FIRST REVIEW
WC³ Project #: 217-525-098

Subject: SPM – Parcel 2C Building – Plan Review Comments

Plan Review Comments

Project Name: SPM – Parcel 2C Building
Location(s): 5752 Copper Crest, Eden, UT
Checked By: DeAnn Wilde

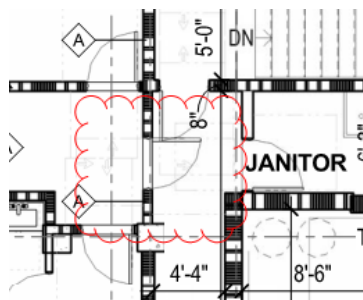
A6. Fire Separation Distances: Please address the following on the Site Plan:

A. Please provide imaginary property lines between all structures on the site plan to show the fire separation distances between all buildings and structures on the site. This would include existing or proposed buildings on the site.

B. Based upon the FSD, additional fire ratings for the exterior walls of the buildings may be required, in accordance with Table 602.

C. Please provide a separate opening analysis for each building on the site. The analysis shall be based upon the separation distances determined, in accordance with above definition and Table 705.8.

I. *Advisory (no response required): The opening analysis shall be based upon the closest distance from the face of the building to the imaginary property line and the building*
